Re: San Mateo Citywide Objective Design Standards - City Council Meeting Date & Updated Standards

An updated Citywide Objective Design Standard (ODS) document is available [online](#) for review. This document has been updated in response to the modifications proposed by the Planning Commission at their October 24, 2023 hearing.

Figure 21: Possible ways to divide a horizontal mass into three elements (Section 4.1.4).

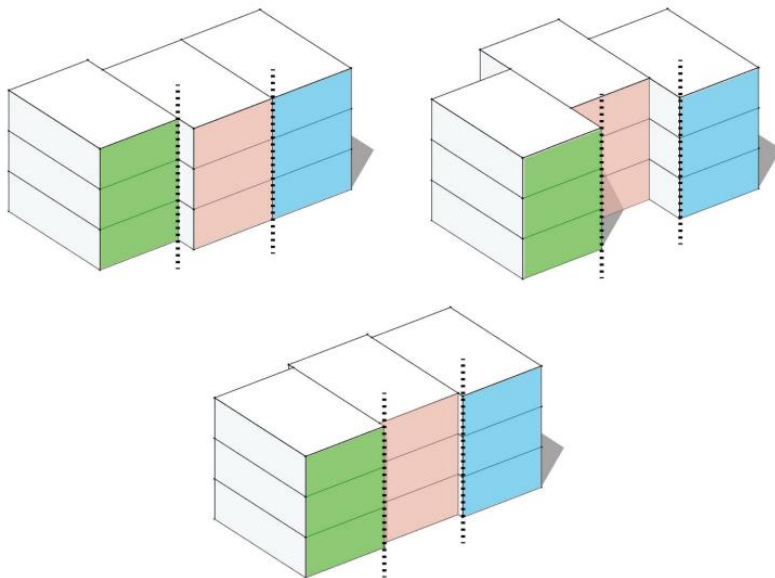
7. Section 4.1.4 – Qualify minimum change between planes and minimum façade portions for massing breaks

Section 4.1.4 requires that structures of three (3) or more stories must follow the rule of thirds and divide the structure into at least three primary masses. In addition to the changes recommended by the Planning Commission, we also recommend providing clear flexibility to determine the width of the primary masses, and *not* to require each to be exactly one-third of the structure. Such a requirement could unintentionally constrict potential uses and design programs. Instead, the standard could include a minimum percentage of overall façade length (i.e., require the minimum width of each primary mass to be at least 20% of the overall façade length). In addition, this requirement should also specify a minimum two (2) feet change in plane between each massing break to assure that the breaks are more than perfunctory.

Accordingly, we recommend the following revisions to Section 4.1.4 and the removal and/or replacement of Figure 21:

Structures of three (3) or more stories (measured from existing grade) shall ~~follow the rule of thirds in which a structure is~~ be divided into at least three primary masses, where each primary mass is separated by at least a two (2) foot minimum change in plane between each massing break, and where each primary mass shall contain a minimum width consisting of at least twenty (20) percent of the overall façade length. ~~Possible ways to break a horizontal mass into three elements are illustrated below.~~
